SECTION 08 71 00 - DOOR HARDWARE - ADDENDUM # 1

JOSEPH BONNHEIM **ELEMENTARY SCHOOL**

ADD ADDENDUM # 1

PLAYGROUND UPGRADES AND LANDSCAPE

DOUBLE PEDESTRIAN GATE SINGLE PANIC

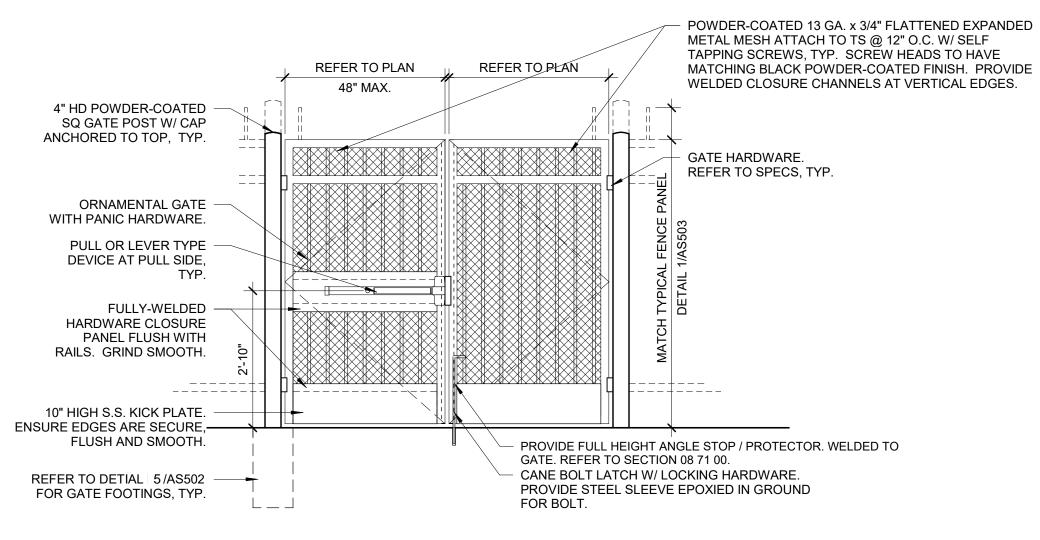
6.50 (N) 6'-0" HIGH x (2) 4'-0" WIDE DOUBLE SWINGING ORNAMENTAL PEDESTRIAN EGRESS * GÁTE. REFER TO DETAIL 2/AS502. 6.54 PROTECT (E) OUTDOOR BENCH TO REMAIN

PARTIAL SITE PLAN - ELECTRICAL

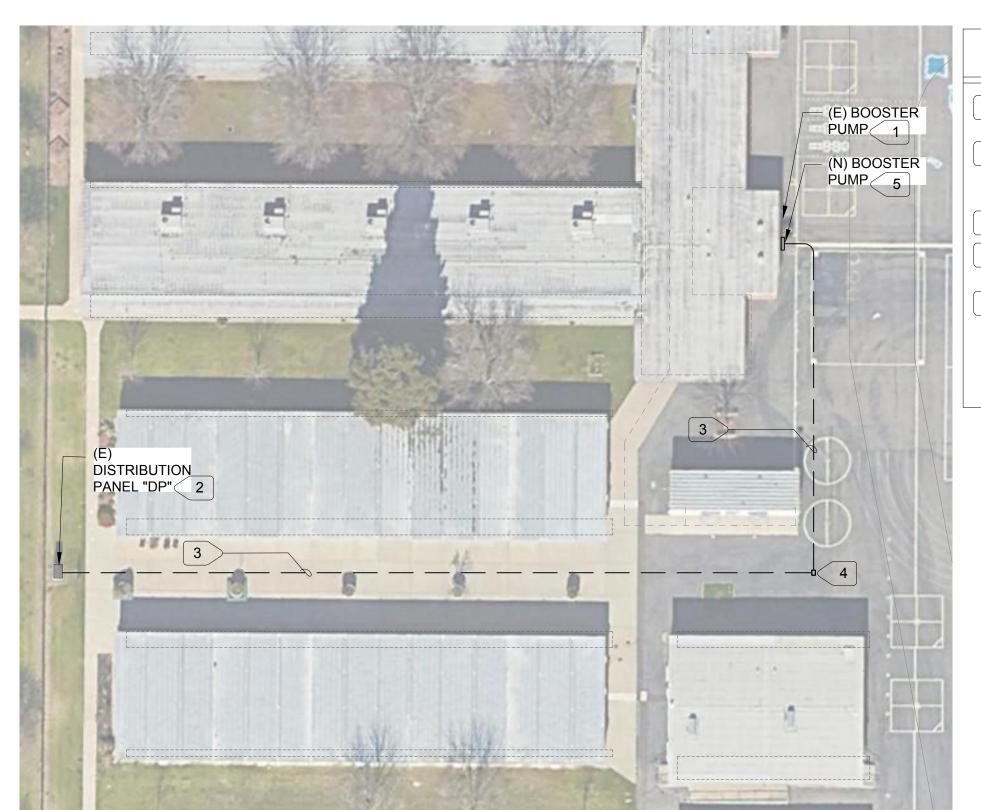
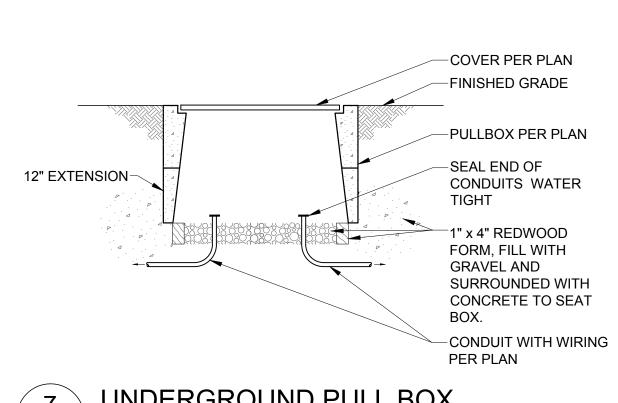
DISCONNECT (E) BOOSTER PUMP. REMOVE WIRING BACK TO SOURCE. REMOVE EXPOSED CONDUITS, DISCONNECT, ETC. PATCH AND PAINT.

- 2 PROVIDE (N) 50/3 CIRCUIT BREAKER IN (E) SPACE. PROVIDE ALL PART AND PIECES FOR COMPLETE INSTALLATION. PROVIDE PHENOLIC ENGRAVED LABEL TO READ: "BOOSTER PUMP".
- 3 > 3#6, 1#10G IN 1" PVC SCHEDULE 40 CONDUIT. DIRECTIONAL BORE.
- 4 > PROVIDE N16 PULLBOX WITH TWO EXTENSION AND CONCRETE LID WITH HOLD DOWN BOLTS. INSTALL FLUSH WITH GRADE.
- 5 CONNECT BOOSTER PUMP CONTROLLER. FROM CONTROLLER CONNECT (2) PUMPS USING 3#6, 1#10G. USE 1" RIGID STEEL CONDUIT FOR EXPOSED RUN, AND PVC SCHEDULE 40 FOR UNDERGROUND RUN. PAINT EXPOSED CONDUITS TO MATCH SURFACE TO WHICH THEY ARE ATTACHED. PROVIDE CONTROL WIRING AS REQUIRED BY BOOSTER PUMP MANUFACTURER.
